SERVICE BULLETIN

MODEL NAME : Di620
MODEL CODE : 1155
NO. : 038
DATE : 990714
SUBJECT : C0110 DISPLAY

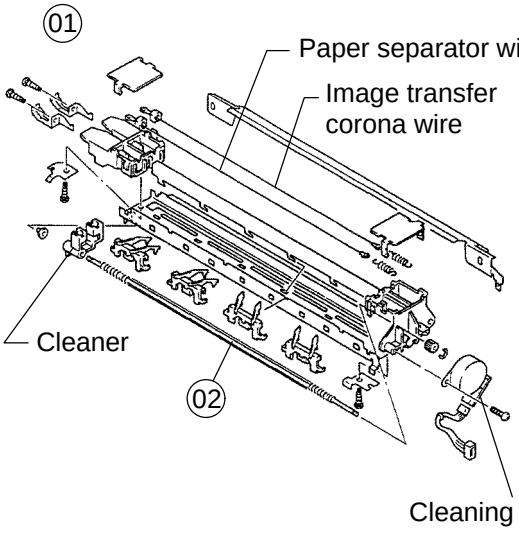
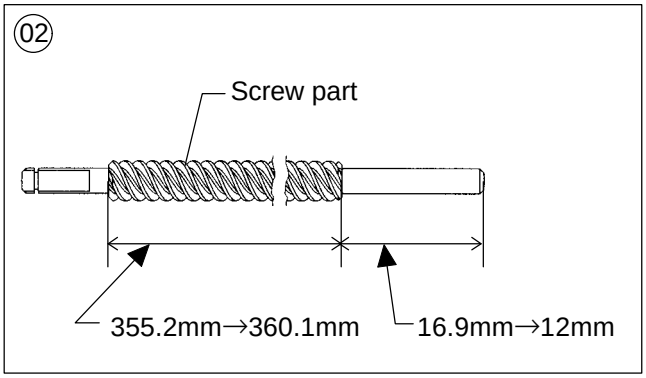
PROBLEM: There is a possibility that malfunction "C0110" may at times occur due to the malfunctioning corona wire cleaning mechanism of the image transfer/paper separator coronas unit (01).

CAUSE: The corona wire cleaner moves back and forth on the corona wire, controlled as detailed below. If, however, there are variations in the accuracy of parts of the image transfer/paper separator coronas unit (01), the cleaner reaches the very end of the screw of the transport shaft (02) and goes beyond the screw part before 11.6 sec. elapse after the cleaning motor (M8) has started turning forward.

SOLUTION: The screw part of the transport shaft (02) has been made longer to give allowance for the cleaner motion.
